WATER DISTRIBUTION SYSTEM to serve HODGES 6TH ADDITION

CITY OF WICHITA, KANSAS

2022-003275PPW

APPROVED AS NOTED
 BY WICHITA PUBLIC WORKS
 ENGINEERING DIVISION

LINE 1

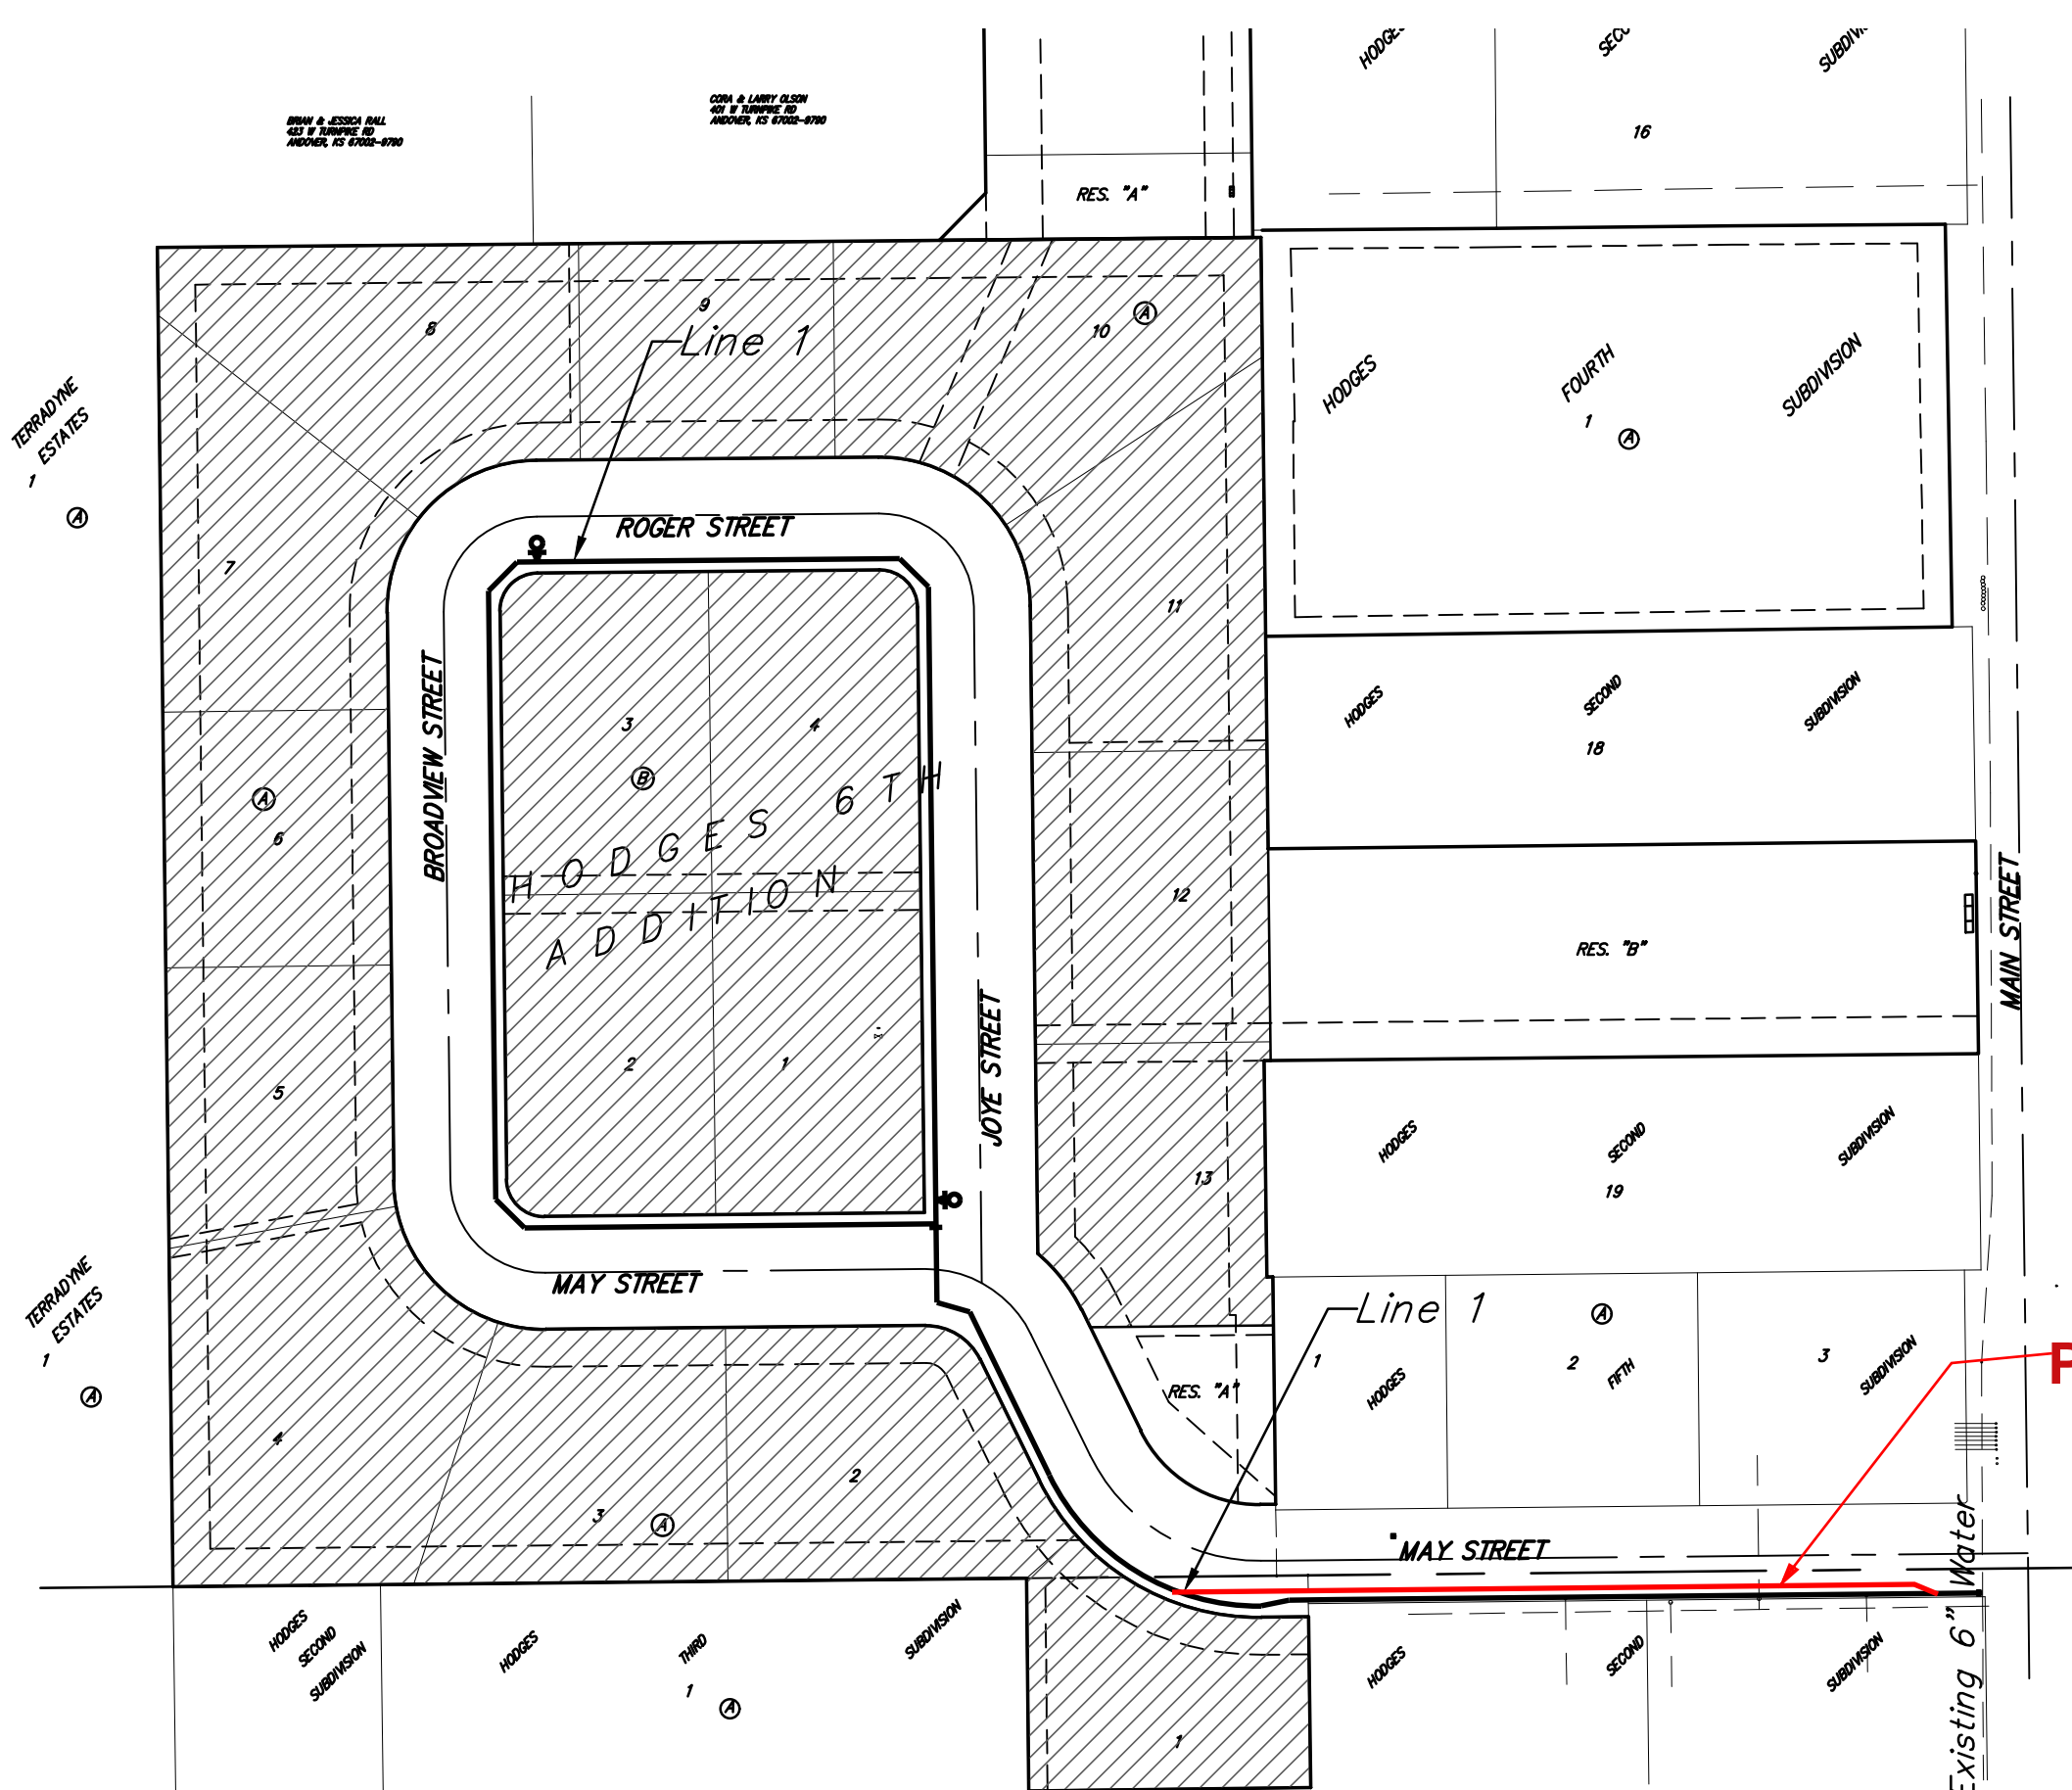
Pipe Moved 3' North
